UNITED STATES PATENT AND TRADEMARK OFFICE

APPLICATION NO.	FILING DATE	FIRST NAMED INVENTOR	ATTORNEY DOCKET NO.	CONFIRMATION NO.
09/666,553	09/21/2000	Yasuhiko Nomura	001222	7592

Office Action Summary

DETAILED ACTION

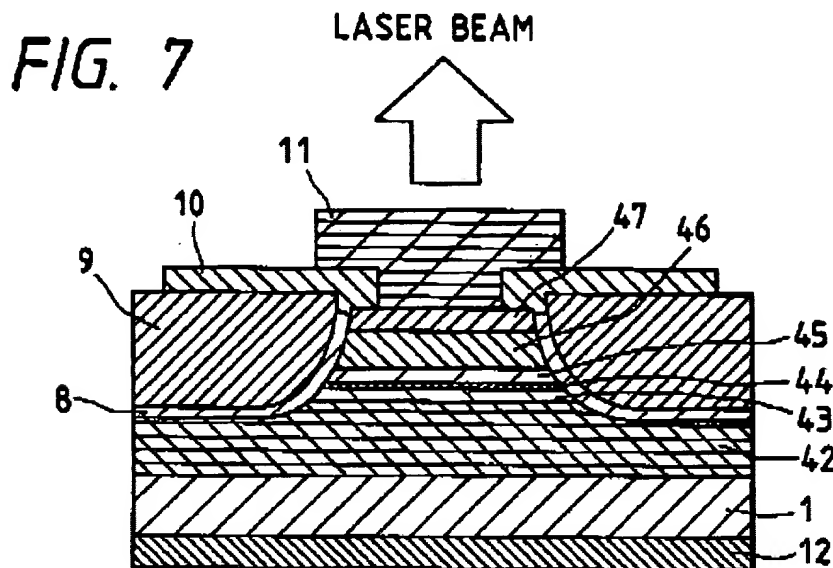
In response to applicant's first argument, it is disagreed that Kondow does not teach the additional limitation, as stated above. First, attention is directed to applicant's figure 3, which shows a dielectric film 12B formed on a surface of a nitride-based semiconductor layer including an emission layer (7). Note that the dielectric film (12B)

contains a nitride (112a or 112b) on the side of the interface between the dielectric film (12B) and the nitride-based semiconductor layer (including layer 7). Also the dielectric film (12B) contains an oxide (either 112b or 112c) on the side opposite to the nitride-based semiconductor layer (including layer 7). Similarly, since Kondow discloses a dielectric Bragg reflector (11) comprising alternately stacked SiN and SiO layers, there is at least one SiN layer that is positioned closer than at least one SiO layer to the nitride-based semiconductor layer.

In response to applicant's second argument above, it is disagreed that "directly" must be read into the claim and further it is disagreed that applicant is claiming that the nitride film is formed directly on the surface of the nitride-based semiconductor layer, because applicant has claimed a broader scope which does not require it. The claim requires that a dielectric film be formed on a surface of the nitride-based semiconductor layer. Kondow teaches this. The claim requires that the dielectric film contain a nitride *on the side* of the interface between the dielectric film and the nitride-based semiconductor layer. It does not require that the dielectric film containing a nitride directly at the interface, as argued by applicant.

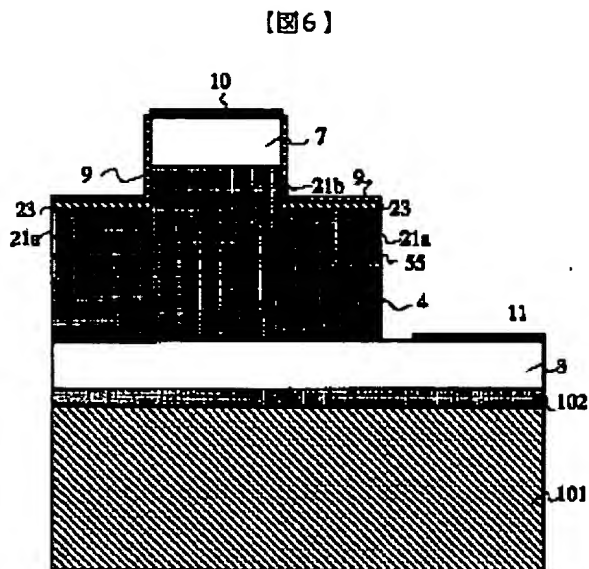
3. Claim 17 is rejected under 35 U.S.C. 102(b) as being anticipated by Inoguchi et al (JP 09-289358). Inoguchi et al discloses the claimed invention. Figure 6 illustrates the claimed invention. Note the dielectric layer 9 on the flat portion of the cladding layer 21a and the side surface of the ridge portion 21b.
